2024 SWEPCO RFP Questions & Answers

Posted 3/25/2024

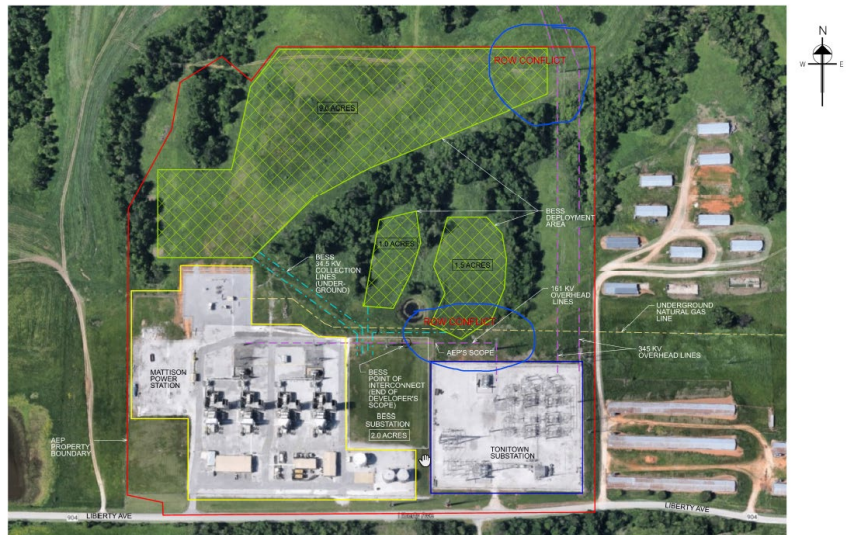
Question #28 (Mattison): What is the required clearance from the transmission lines to equipment for the Mattison Storage Project?

As per the AEP ROW 161kv Easement attachment, the ROW for the North/South 161kv double circuit is 150'. The two circuits are 50' apart so the ROW clearance for each circuit would essentially be 100' (50' apart and 50' to the east and west). The East/West line coming into the plant has a 100'

ROW. The Mattison BESS ROW Conflict map has the areas highlighted that need adjusted to stay out of the ROW. The following documents will be added to the PSA RFP Appendix S:

1. AEP ROW 161 kV Easement.pdf
2. Mattison BESS ROW Conflict Map.pdf (Picture shown below)
